Syar Napa Quarry Expansion Surface Mining
Permit #P08-00337
Napa County Department of Planning,
Building & Environmental Services

Final Environmental Impact Report

November 2014

SKYLINE TRAIL

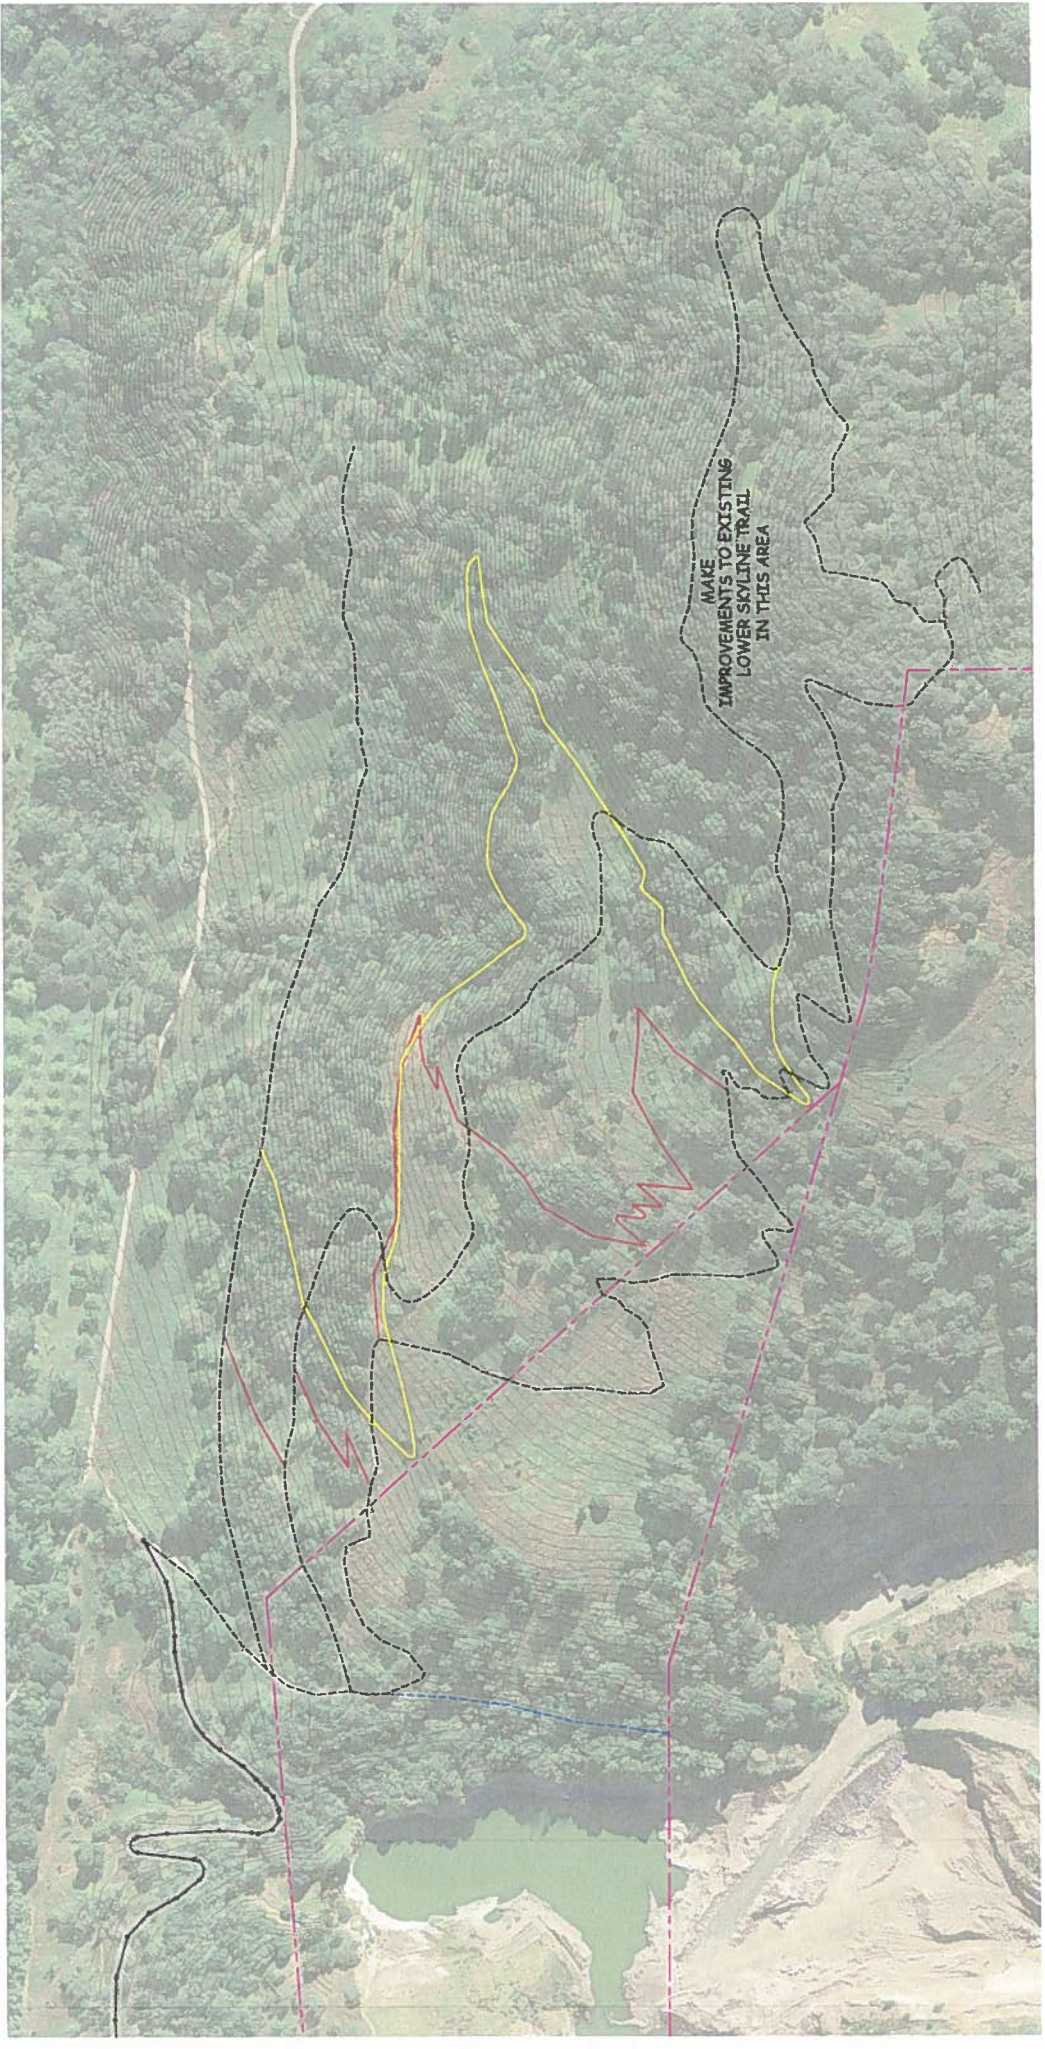
- Section 4.14-2 Trail Abandonment, Fence and Trail Relocation: There are several issues with regard to the relocation of a portion of the existing Skyline Trail that encroaches on the quarry property and the possible future relocation of additional segments of the existing Skyline Trail and Buckeye Trail as proposed in the revised drawing of Figure 4.14-1 attached to this document.

- Pages 4.14-4 and 4.14-5 Easement or Agreement with respect to trails identified in Insets B, C, and D of figure 14.4-1
 - The portions of the trails that are identified in Insets B, C, and D of Figure 4.14-1 as encroaching on Syar property should not be subject to relocation as they are within the 50 foot Mining Setback and Exclusion Area as identified in Figure 4.14-1. Therefore, as that portion of the Syar property cannot be used for mining operations, Syar should consider granting Skyline Park a permanent easement, rather than the suggested temporary easement or lease agreement, with respect to those portions of the trails. U-11
